# Accessibility Survey

## City of Downey Firestone Boulevard & Arnett Street

Date of Inspection  
5/4/2017

**Disability Access Consultants**

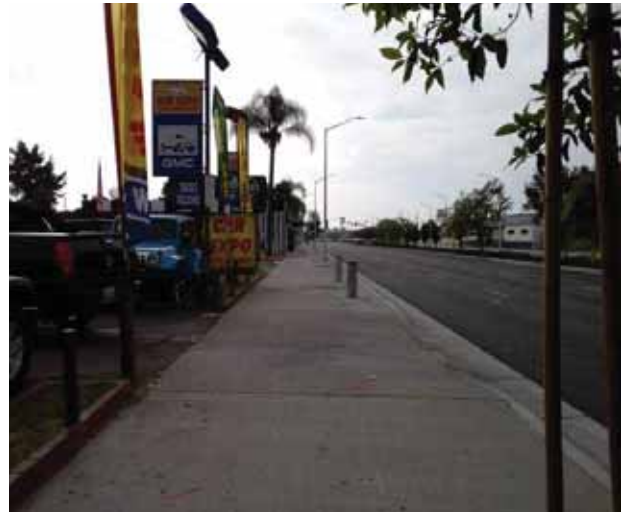
There are no detectable warnings where the pedestrian route crosses vehicular traffic.

**On-Site Finding** Not Found

Provide detectable warnings.
